**From:** Lasley, Timothy G  
**Sent:** Thursday, September 20, 2018 1:57 PM  
**To:** 'adavies@williamsmullen.com'  
**Cc:** Werner, Jeffrey B; Mess, Camie  
**Subject:** BAR Actions - September 18, 2018 - 0 East Water Street

BAR 18-07-04  
0 East Water Street  
Tax Parcel 570157800  
Alan Taylor, Owner/ Ashley Davies, Applicant  
Maintenance and Rehabilitation

**CITY OF CHARLOTTESVILLE  
BOARD OF ARCHITECTURAL REVIEW  
STAFF REPORT  
September 18, 2018**

**Pocket Park at Coal Tower** (Review of Maintenance and Rehabilitation is complete.)

# WATERSTREET - COAL TOWER POCKET PARK DESIGN

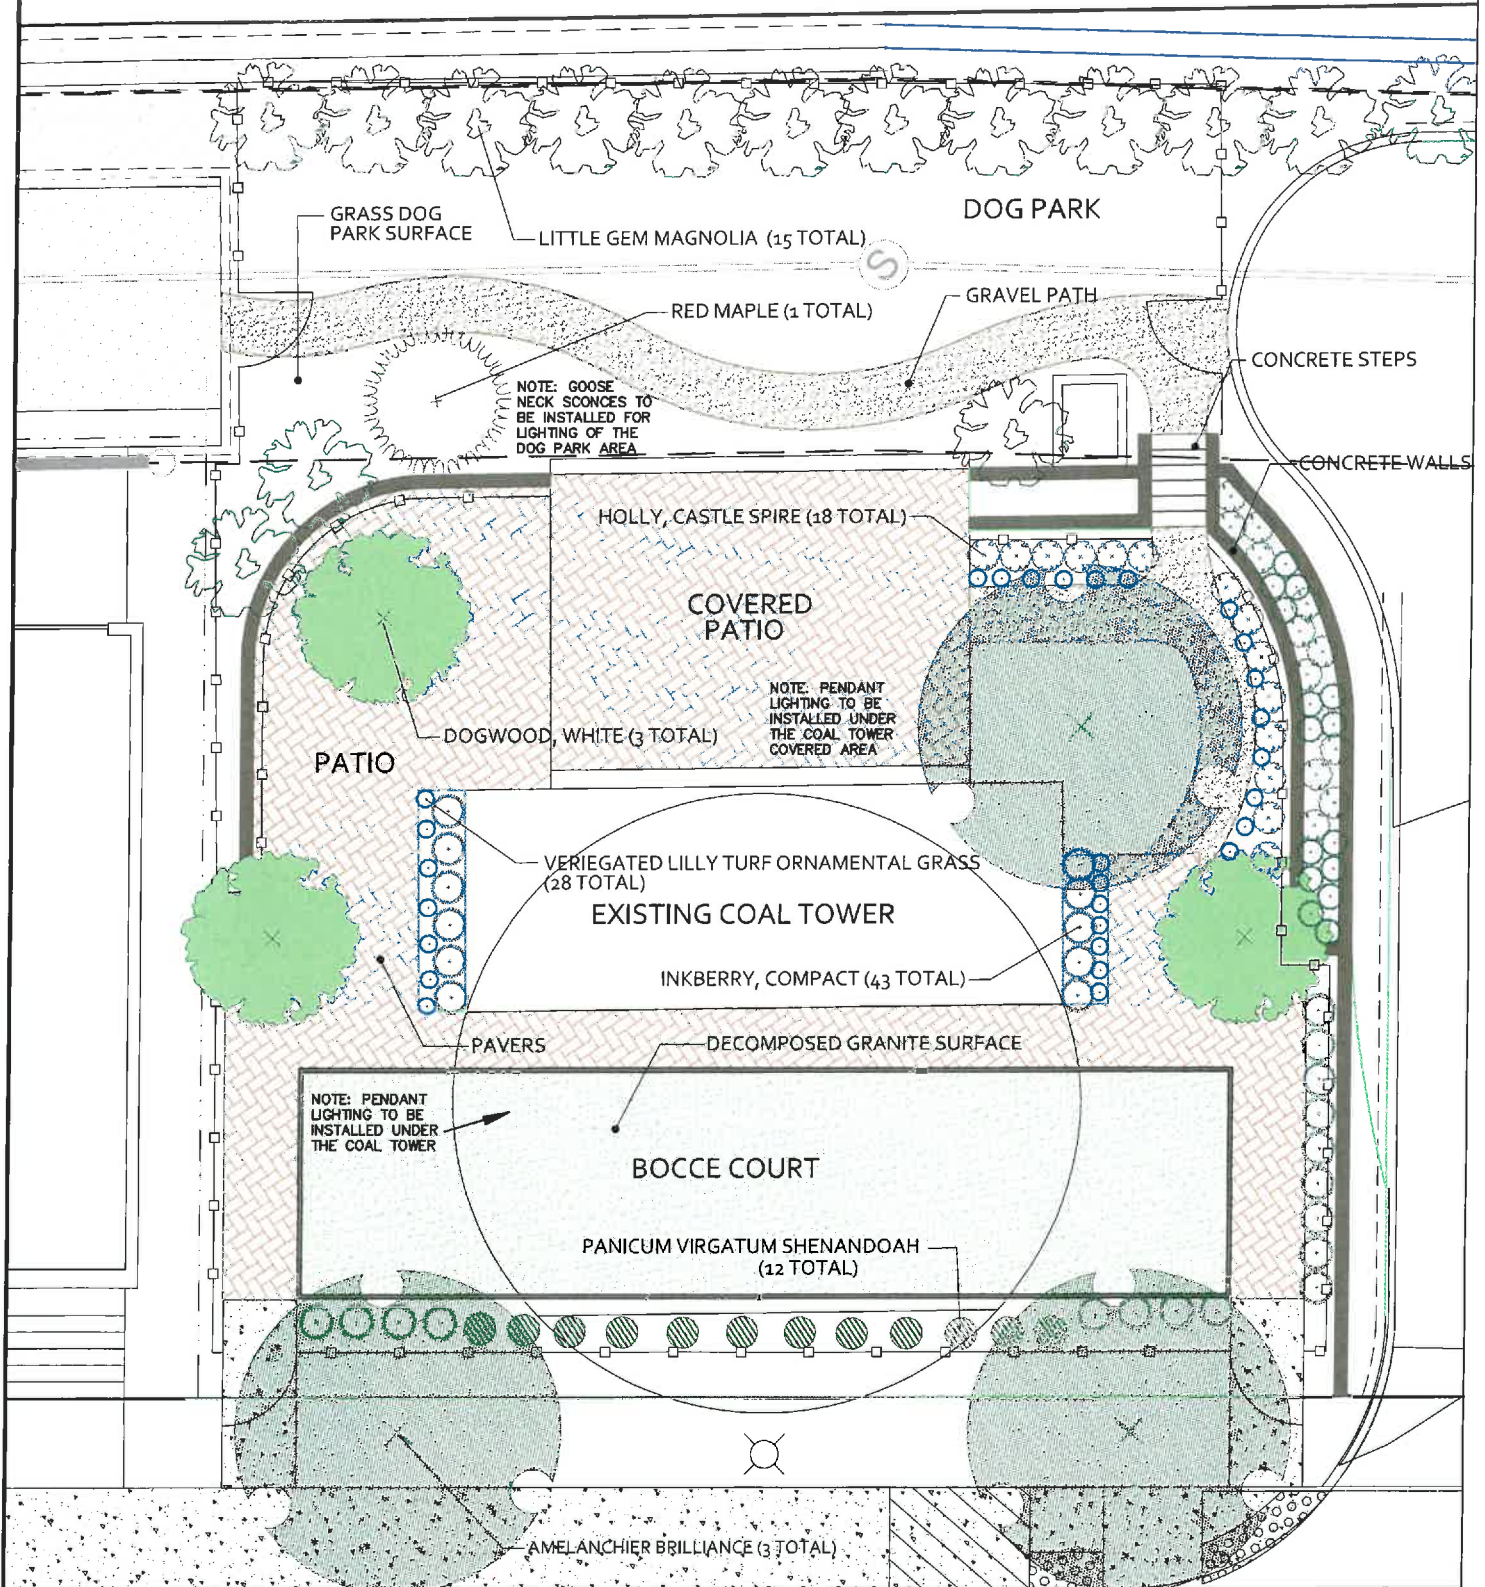
**Motion: Schwarz moved having considered the standards set forth within the City Code, including City Design Guidelines for Site Design and Elements, I move to find that the proposed park design at the Coal Tower satisfies the BAR's criteria and is compatible with this Individually Protected Property, and that the BAR approves the application with the following conditions:**

- **Final light fixtures selected will be submitted for the BAR review;**
- **Lamping not to exceed 3000 color rendering index (CRI);**
- **Interpretative signage and/or displays will be submitted for BAR review.**

No change in proposed design other than revised plantings

- Below Tower: *Variegated Lilly Turf* has replaced *Coral Bell*.
- At Bocce Court: *Panicum Virgatum Shenandoah* has replaced *Regal Mist Muhly Grass*, *Tulip/Daffodil Mix*, and *The Blues Grass*

- Beneath the Tower (from applicant's July 2018 submittal): Replace existing lighting fixtures underneath the coal tower with bronze finish pendant type light fixture, replacement fixture is similar to existing sconce fixture at the top of the coal tower (also to be replaced). (Links below. See also attached cut sheets)
  - [https://www.lampsplus.com/products/rlm-heavy-duty-8-and-one-quarter-inch-h-textured-bronze-outdoor-hanging-light\\_12t68.html](https://www.lampsplus.com/products/rlm-heavy-duty-8-and-one-quarter-inch-h-textured-bronze-outdoor-hanging-light_12t68.html)
  - <http://www.troyrlm.com/download/PDF/Standard.pdf#zoom=100>
- Dog Park Area: Gooseneck sconces at Dog Park Area.
- Street Light: Confirm fixture indicated at Water Street sidewalk.

- The existing fencing matches what was provided by the City on the other side of Water St. Proposed fencing at the Coal Tower to match existing fencing.

Design: The BAR should discuss the appropriateness of the revised park design in the context of the Coal Tower and the surrounding area.

Plantings: Discuss appropriateness of revised plantings.

Lighting: Review location of proposed fixtures and recommend appropriate conditions/requirements relative to lamping type, light temperature, etc.

Interpretative Signs: The installation of interpretive signage was discussed at prior meetings. BAR should note as a condition of approval that interpretative signage and/or displays will be submitted for BAR review
